UNITED STATES PATENT AND TRADEMARK OFFICE

APPLICATION NO.	FILING DATE	FIRST NAMED INVENTOR	ATTORNEY DOCKET NO.	CONFIRMATION NO.
10/644,465	08/20/2003	Henry Marshall Israel	2550-001	5945

Office Action Summary

- 1) ☒ Responsive to communication(s) filed on 25 June 2007.
- 2a) ☒ This action is **FINAL**. 2b) ☐ This action is non-final.
- 3) ☐ Since this application is in condition for allowance except for formal matters, prosecution as to the merits is closed in accordance with the practice under *Ex parte Quayle*, 1935 C.D. 11, 453 O.G. 213.

FIG. 3A

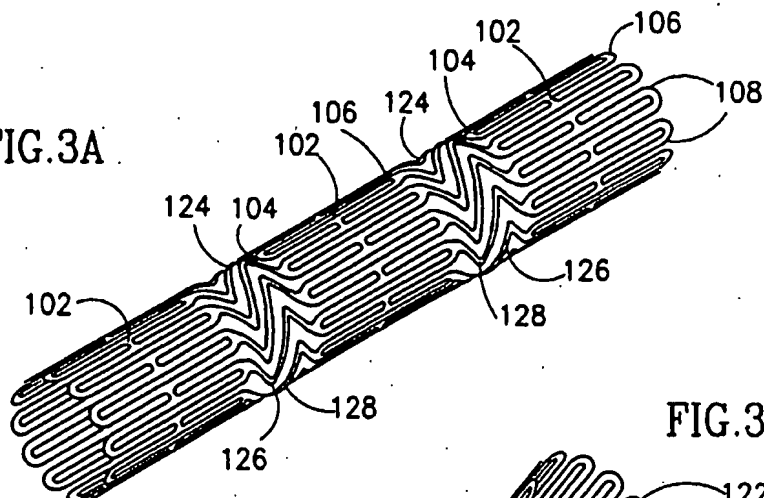
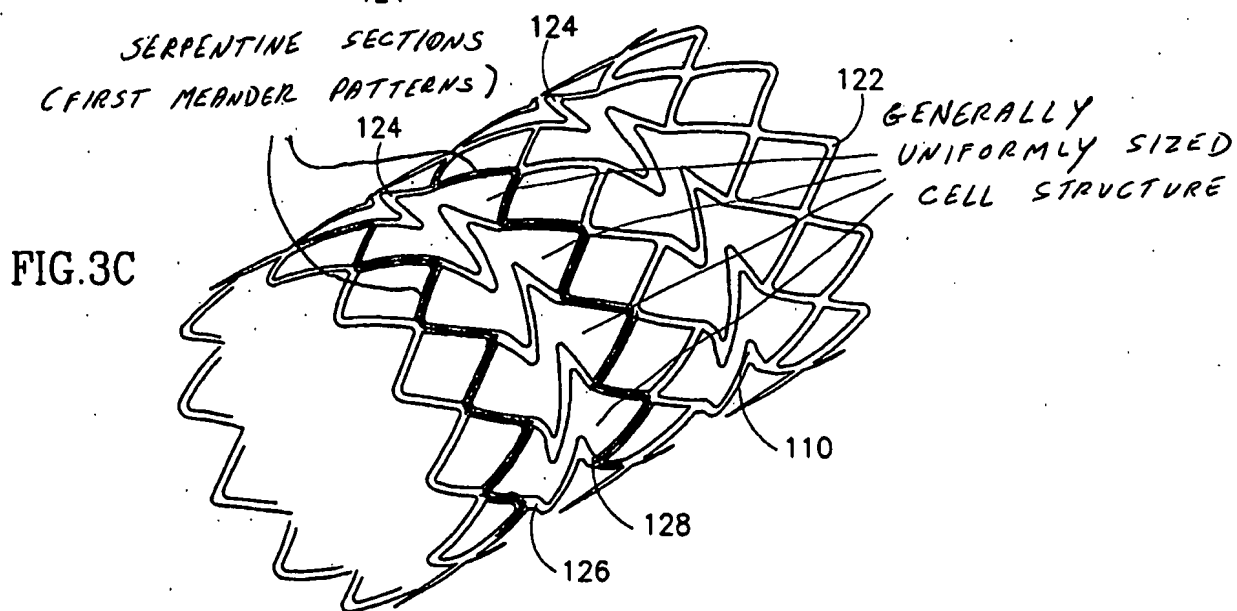
Claims 42, 44-49, 51, 57-60, 63-69 and 72 are rejected under 35 U.S.C. 102(e) as anticipated by or, in the alternative, under 35 U.S.C. 103(a) as obvious over Pinchasik et al. (5,449,373). As to claim 42, Pinchasik et al., in figures 3A-3C, disclose a plurality of continuous serpentine sections (as shown in the attached appendix A), a plurality of flexible connectors 124 forming a generally uniformly sized cell structure (as shown in appendix A), each of the connectors being elongatable in a bend of a lumen to maintain a generally uniformly sized cell structure in the bend after expansion (the above identified cells will inherently still be generally uniformly sized in the bend since any difference between the cell sizes will be relatively small, particularly in a small bend. Alternatively, it would have been obvious that the cells will still be generally uniformly sized in the bend when the bend is small since any effect the bend would have on the cell size would be small due to the smallness of the bend. As to claim 46, the top end of the Pinchasik et al. connectors are open, closed, open and closed along the longitudinal axis of the stent from the left to the right as seen in figures 3A-3C. As

to claim 57, Pinchasik et al., in figures 3A-3C, disclose first meander patterns and second meander patterns as shown in the attached appendixes A and B.
